PEB#000079
Recall of Certain Plastic Ripcord Handles Optional
1979

Relative Workshop Recalls. Certain Plastic Reserve Ripcords

Recalled Handle

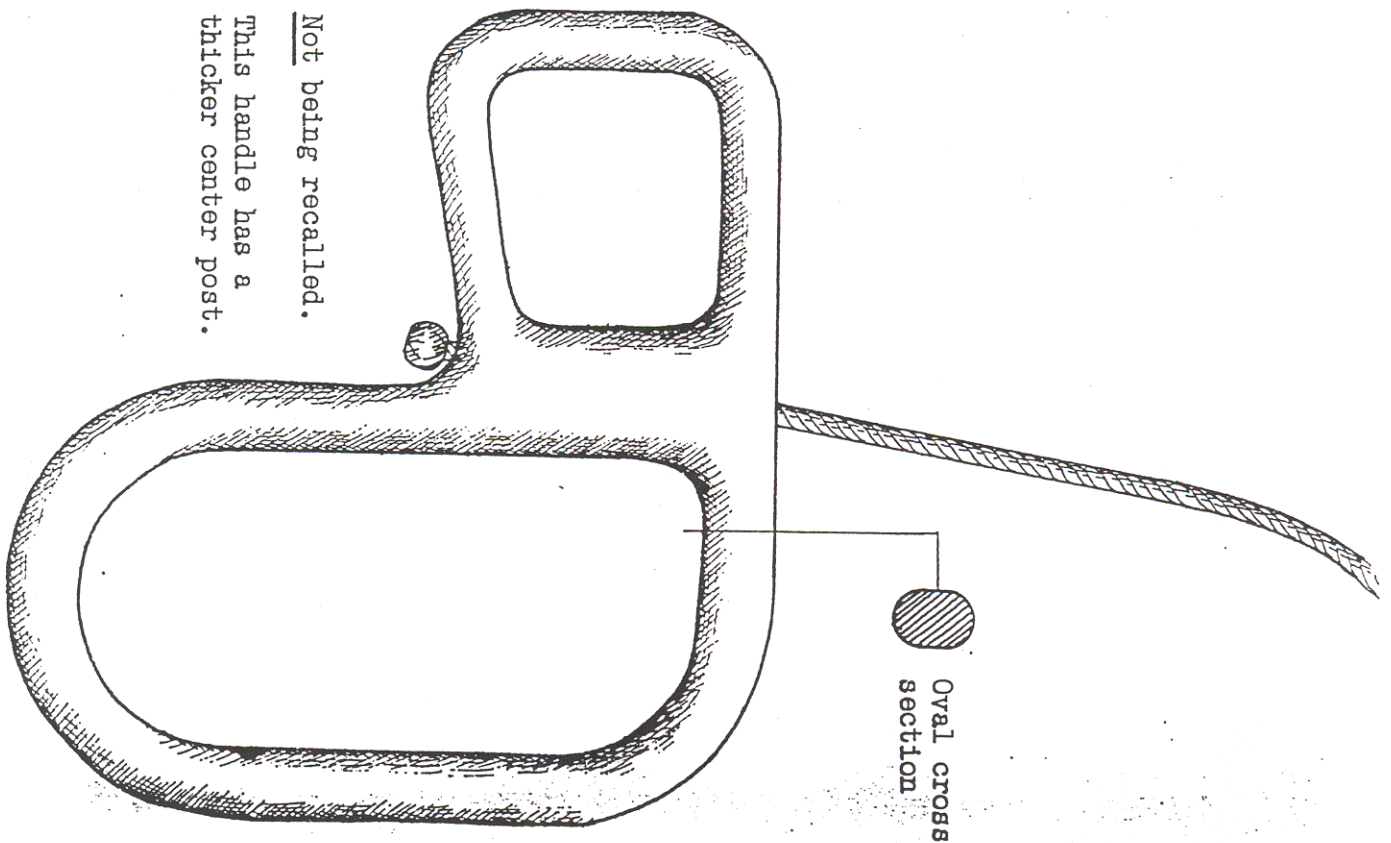
The ripcords being recalled were obtained from the Jump Shack, Inc. They are made of tan nylon, have a round cross section and a smooth finish, The cable passes through a post that has the same diameter as the rest of the handle.

(Another plastic reserve ripcord handle is not involved in this recall. It has a rougher finish and is made of a translucent plastic. The handle has an oval cross section and a thickened post through which the cable passes. Refer to the illustrations below.)

Note the thinner center post.

Round cross section

Not being recalled.

This handle has a thicker center post.

Oval cross section

Although no injuries resulted from these failures, the Relative Workshop has decided to replace ripcords of this particular type with ones with metal handles. Owners of Wonderhogs equipped with these handles may receive a replacement ripcord by returning the plastic one and the information specified below directly to the Relative Workshop.
